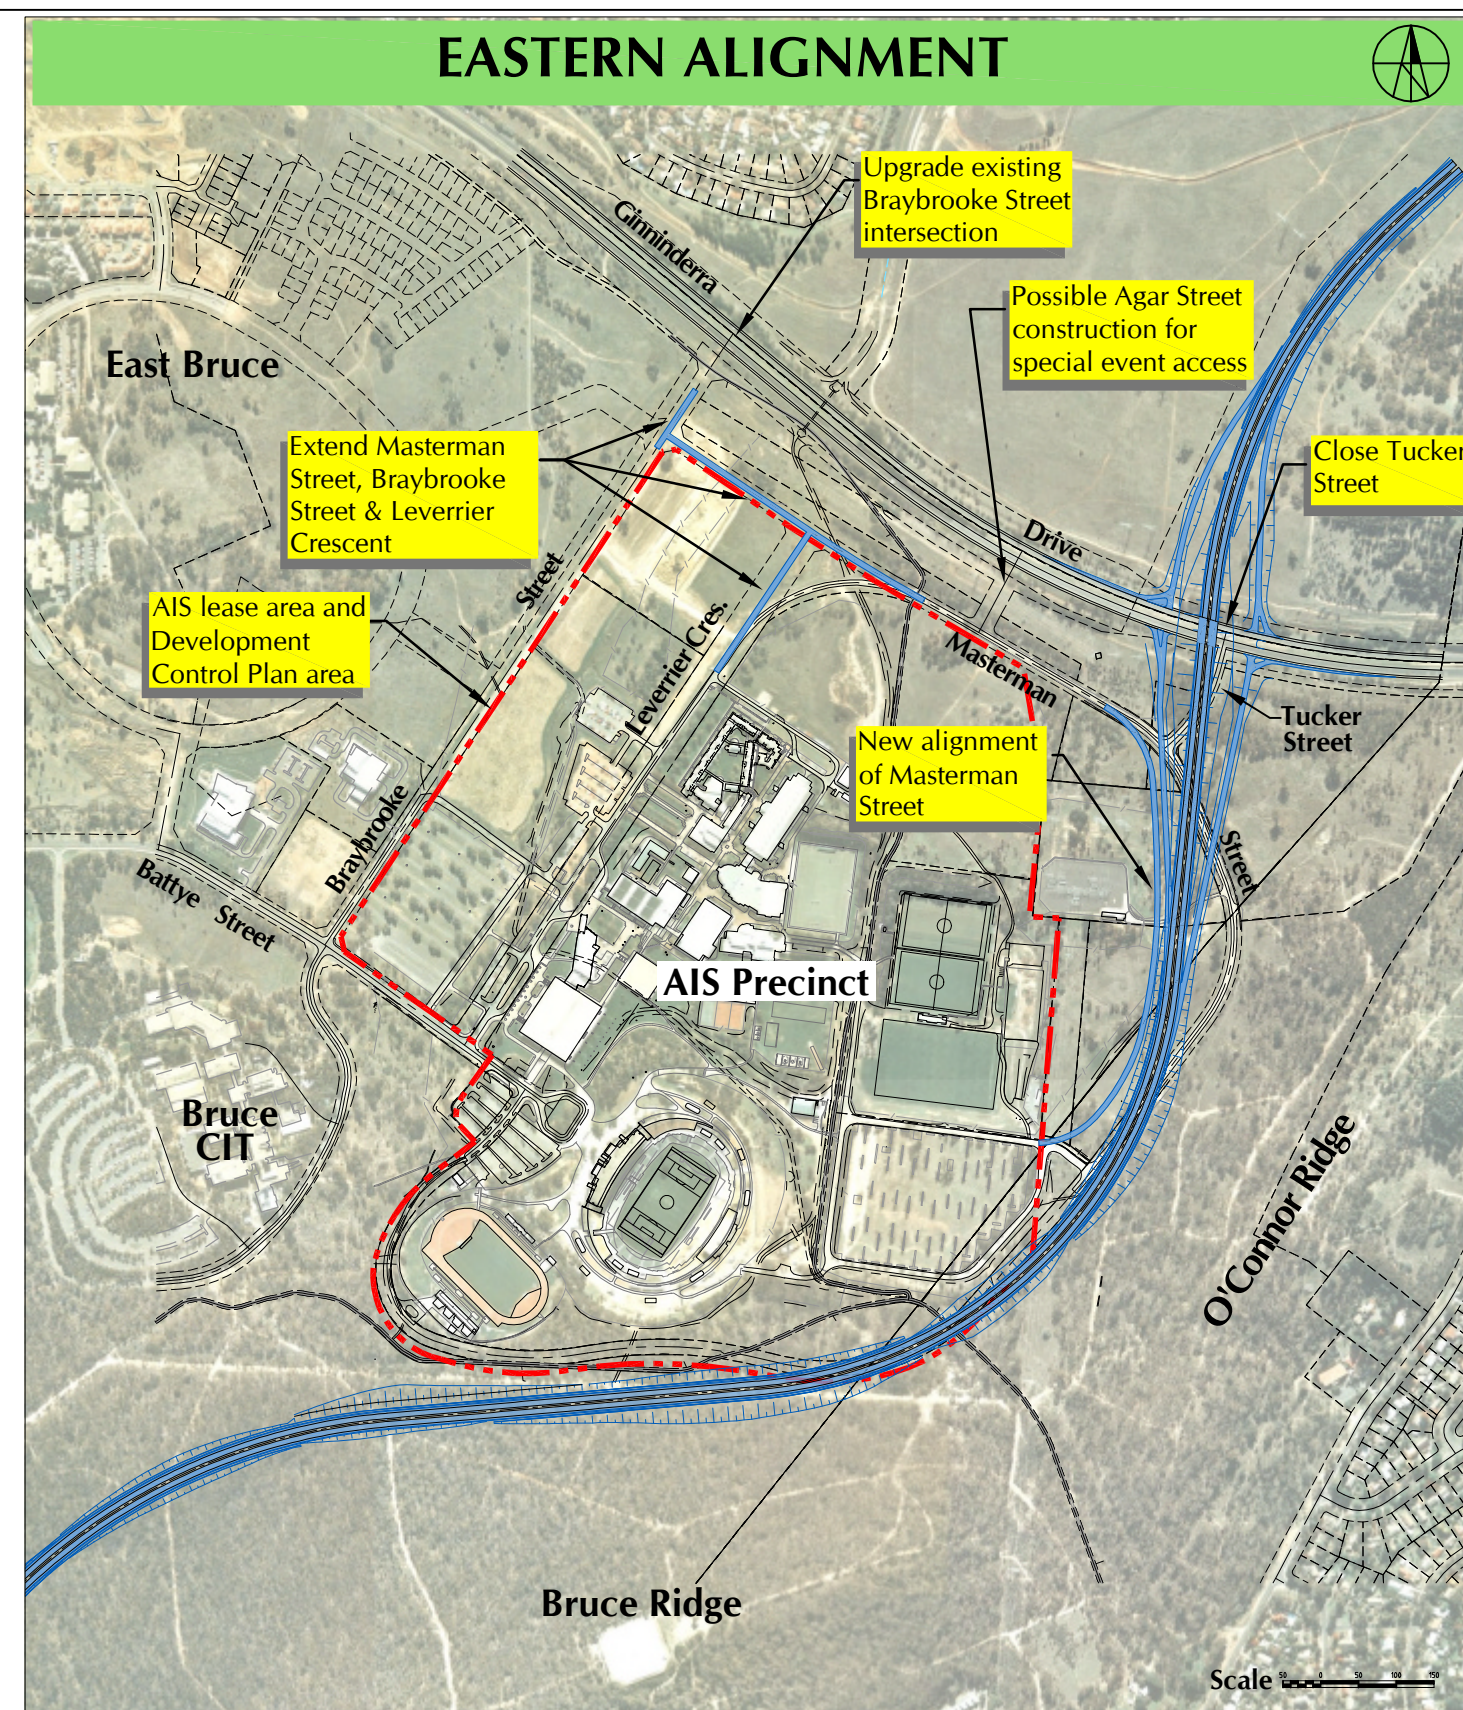
**Comments:**

1. Constrains AIS Masterplanning opportunities.
2. Impact on future development of AIS within its leased area.
3. Amendments to East Bruce / Masterplan required
4. New bridge access to AIS (Link Road) to provide linkage to East Bruce precinct.
5. New bridge on Batty Street
6. New Braybrooke Road intersection with Ginninderra Drive.
7. Upgrade Tucker Street Intersection with Ginninderra Drive.

**Comments:**

1. New works do not conflict with AIS masterplanning and future development.
2. No impact on Bruce East precinct Masterplan
3. Extensions of Braybrooke and Masterman Streets and Leverrier Crescent and possible special event access via Agar Street.
4. New section of Masterman Street required to maintain back-of-house access to AIS and Canberra Stadium carpark
5. Tucker Street closed together with intersection at Ginninderra Drive.
6. Upgrade of existing Braybrooke Street intersection with Ginninderra Drive required.
